Report to the Future Melbourne Committee**Agenda item 6.1****Planning Permit Application: TP-2022-23
204-208 Albert Street, East Melbourne****24 October 2023****Presenter:** Marjorie Kennedy, Acting Director Planning and Building**Purpose and background**

Application number:	TP-2022-23
Applicant:	Whitehaven Property Development Pty Ltd
Owner:	Whitehaven Property Development Pty Ltd
Architect:	Jackson Clements Burrows Architects
Address:	204-208 Albert Street, EAST MELBOURNE VIC 3002
Proposal:	Partial demolition of the existing building, and the development of a multi-storey commercial building and associated works, and a reduction of the car parking requirement
Estimated cost of development:	\$15,000,000
Date received:	21 January 2022
Date amended:	15 September 2023
Responsible officer:	Rochelle Fleming, Senior Urban Planner

REDUCED SETBACK SHADOWS TO EASTERN RESIDENTS - 1:30

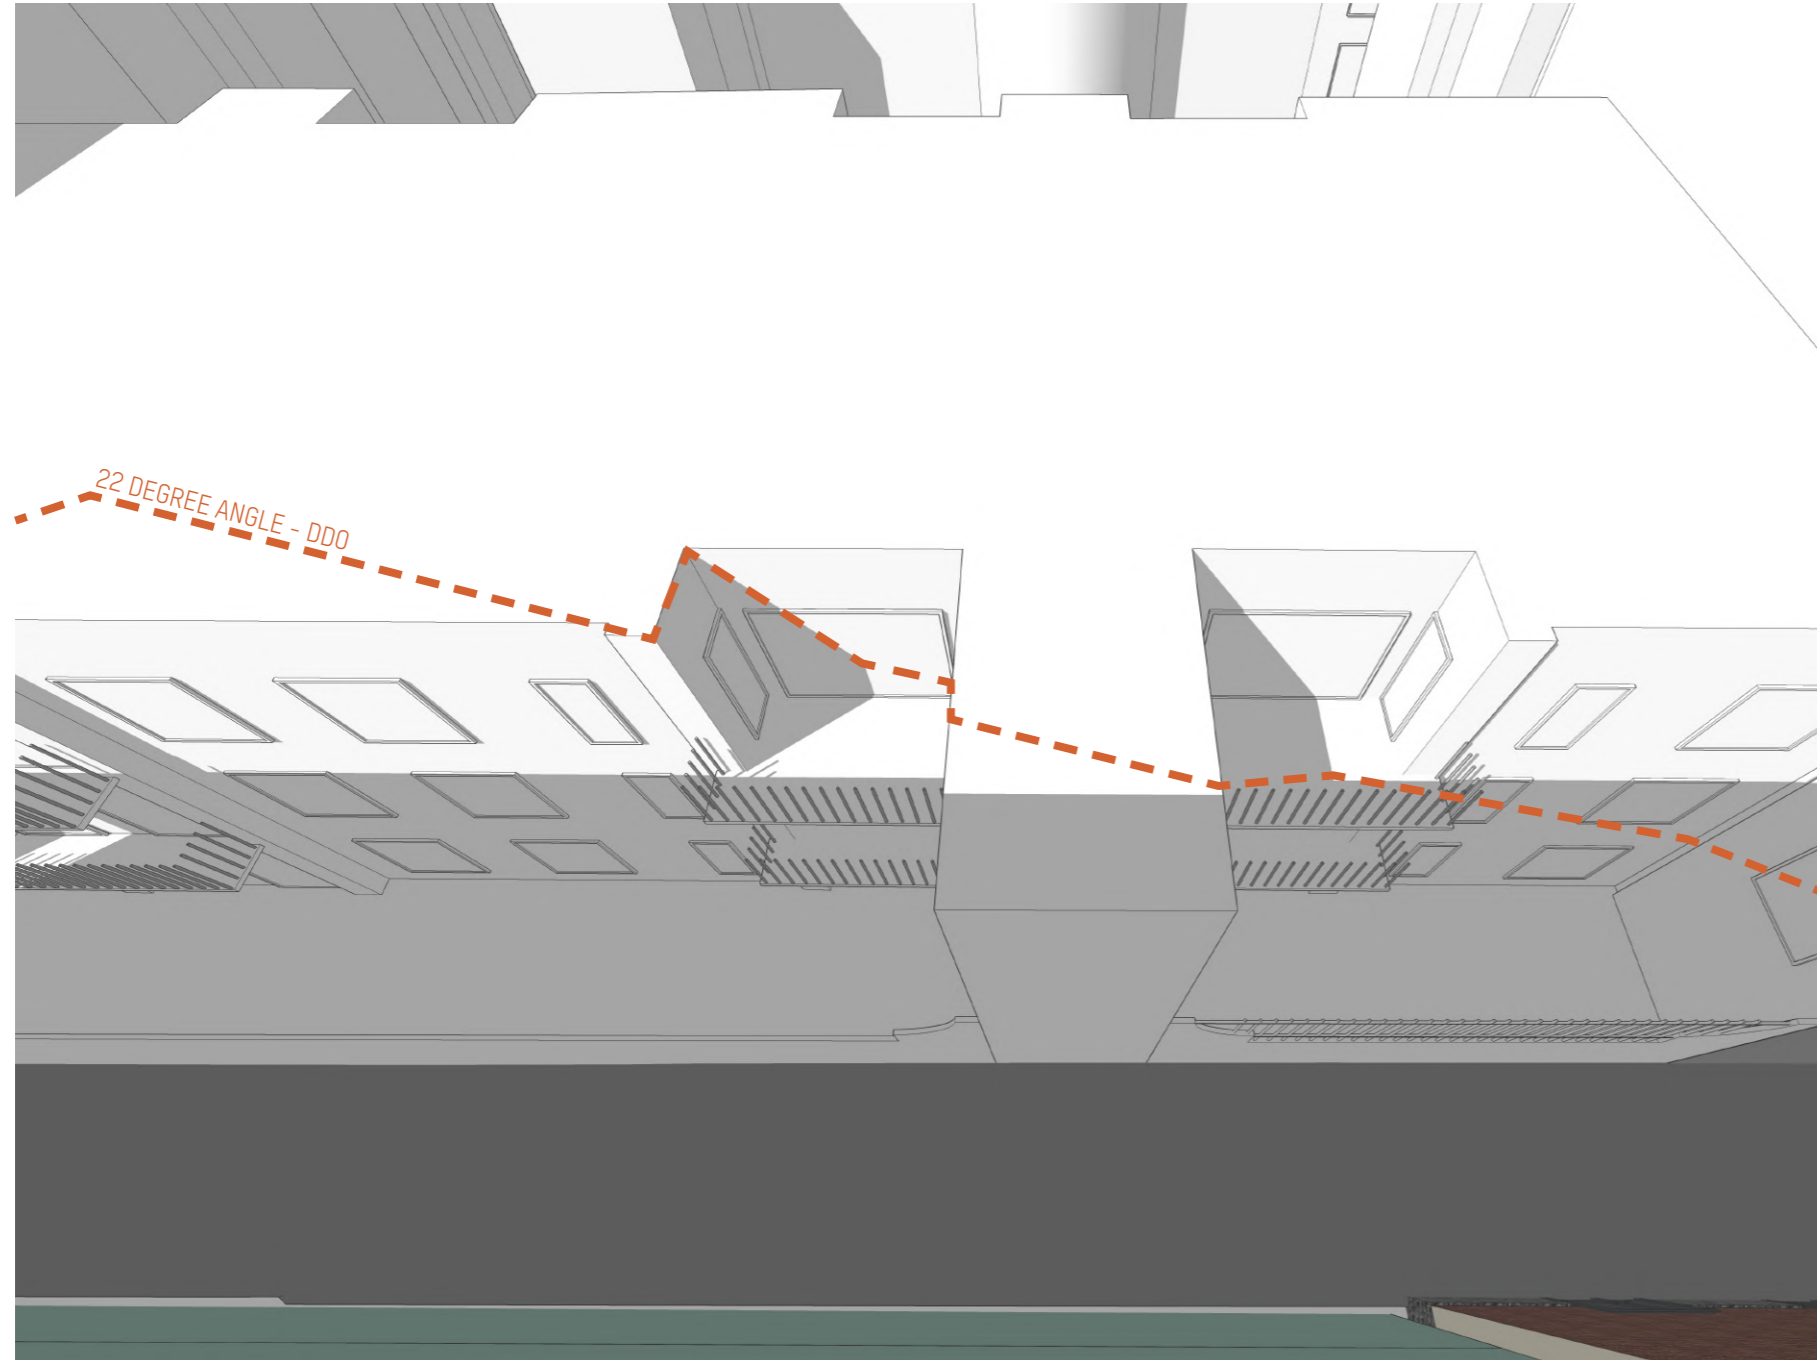
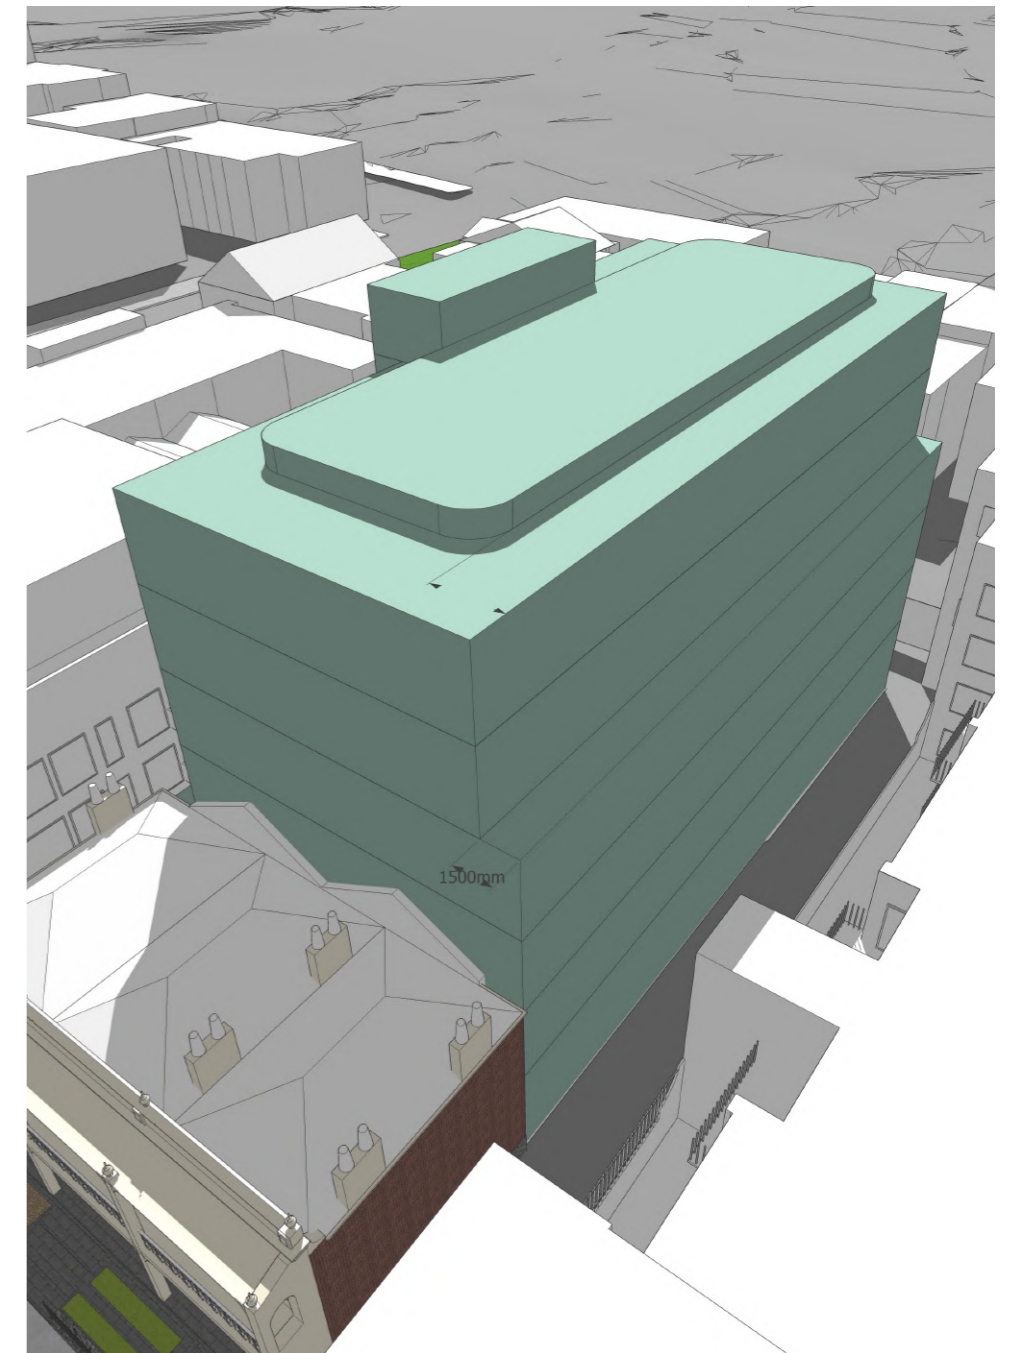
As part of the Section 57A Amended Application the setback to the east of the Site has been reduced from 3.4 metres to 1.5 metres at the upper two levels. This will have a revised visual bulk and outlook impact on the apartments at 200 Albert Street, which is discussed at Section 12.3.1 below.

As Above: Mark up of revised bin room provided by the Applicant

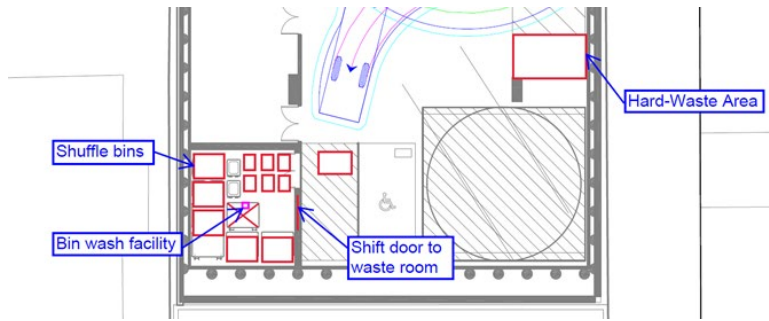
- The bin room is not large enough. Tenants will be required to have access to an 1100L bin for garbage, recycling and paper/cardboard. The submitted plans show only immediate access available to 2x1100L bins.
- Plans are required to show bin wash facility and communal storage space for hard waste.
- Swept path diagrams are required to include the waste vehicles entry/exit manoeuvres from/to street level.

A copy of the above comments were provided to the permit applicant who requested the outstanding information be conditioned. While it is considered possible to condition the outstanding information, a marked up plan was requested from the permit applicant to demonstrate that there is sufficient space to accommodate all required bins and facilities. The below mark-up was subsequently provided by the permit applicant and has been reviewed by Council's Waste Planning Engineer who confirmed the mark up is acceptable. As such, the above requirements will be dealt with via an amended plan and amended WMP condition.

Above: Indicative built form transition on Albert Street associated with the proposed 6-storey addition (Source: Applicant’s submission)

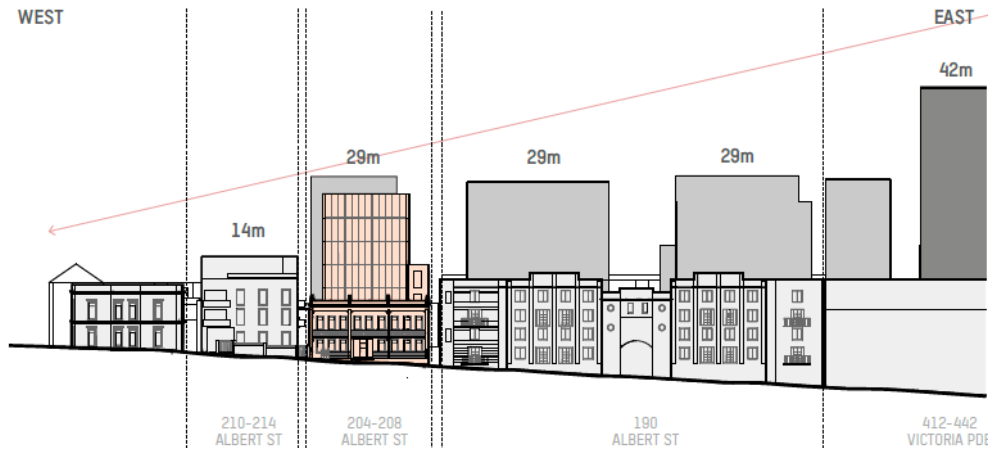
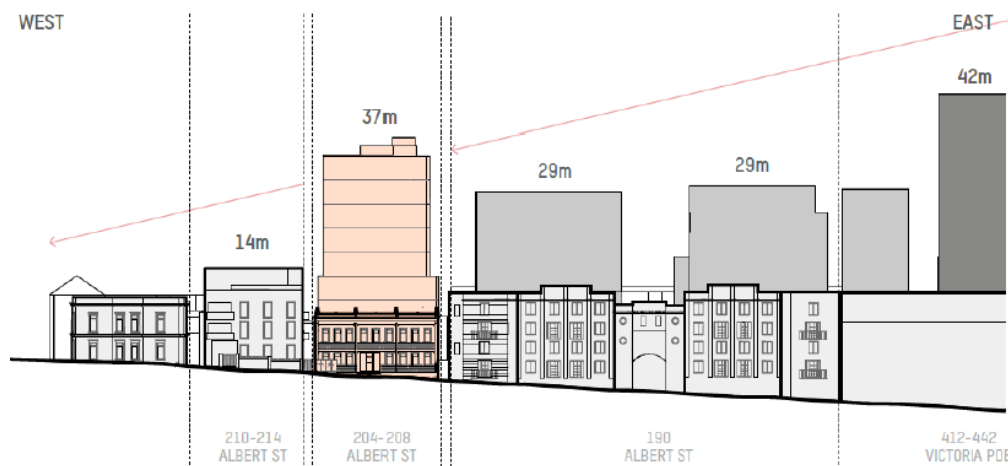
The key design objective at DDO20 that relates to built form and scale requires new development or redevelopment be compatible with the existing scale and character of adjoining buildings and the area. Also relevant is the design objective to minimise the visual impact of buildings on the Fitzroy Gardens and to preserve the amenity of the gardens. Specifically, the Tribunal found that in views towards the Site from the north-east edge of Fitzroy Gardens that the Site falls within a ‘transitional space’ with taller forms in the backdrop and lower forms in the foreground. At paragraph 98 of the decision the Tribunal found that “...a lower form that is less visible, and therefore more compatible to the low rise nature of the immediate heritage surrounds of Albert Street” was needed.

The proposed scheme has been reduced to 6 storeys in height or approximately 22.2 metres in height from the footpath at the centre of the Site to the top of the roof. Rooftop services and screening extend for a height of 1.7 metres above this while the lift overrun extends to 2.7 metres above the roof of the building.

Through the Section 57A Amended Application the permit applicant has also successfully reduced the height of the plant screening (from 2.5 metres to 1.7 metres). The plant screening is also setback 7.1 metres from the southern building line of the proposed addition, which ensures the plant appears as a subservient addition at roof level.

The progression of the proposed development is demonstrated in diagrams below, which show how a reduction in height to 6 storeys allows for a clear visual transition in heights and ensures that the proposed addition will not dominate the Albert Street streetscape. It is considered that the 6 storey addition shown on the decision plans appropriately responds to the adjoining scale and heritage streetscape, thereby addressing the concerns raised by the Tribunal in their decision.

As Above: Land designated as Road overlaid on proposed Ground Floor Plan

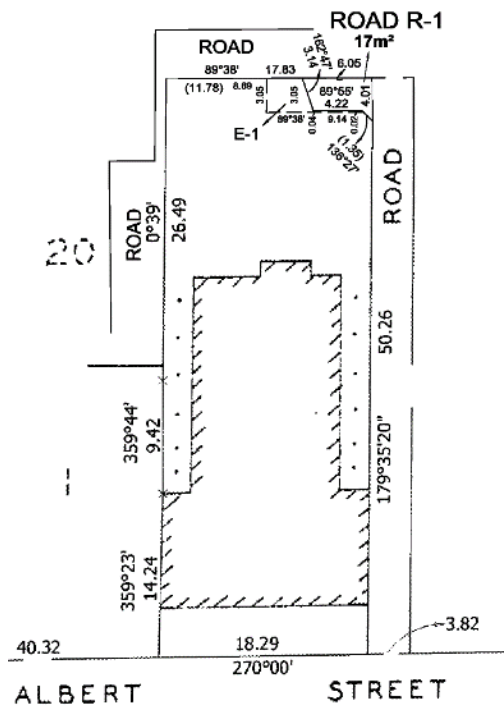
A second issue in relation to access is the applicant's proposal to construct the building over land to the north-eastern corner of the Site that is designated on title as a road. The plan of strata subdivision has been updated since the previous scheme was considered by the Tribunal and the plan of subdivision now includes land designated as a road within the title boundary for the Site.

The proposed development currently involves building over land designated as road. A permit condition will be included on any permit issued requiring the built form be redesigned to sit outside of the land designated as road, unless the land is subject to discontinuation and sale. A revised built form, sitting outside the land designated as road is unlikely to provide a suitable place for a convex mirror within the property boundary. However, a condition requiring a Road Safety Audit prior to commencement will be included on any permit issued which will assess the vehicular, bicycle and pedestrian access arrangements. This will allow any access issues to be resolved prior to commencement of the development.

A condition will also be included on any permit issued, requiring the building be redesigned to sit entirely outside CL1160, unless agreement can be reached for sale and discontinuation of this land. This does not apply to the land identified on the decision plans as a 3 m x 3 m splay.
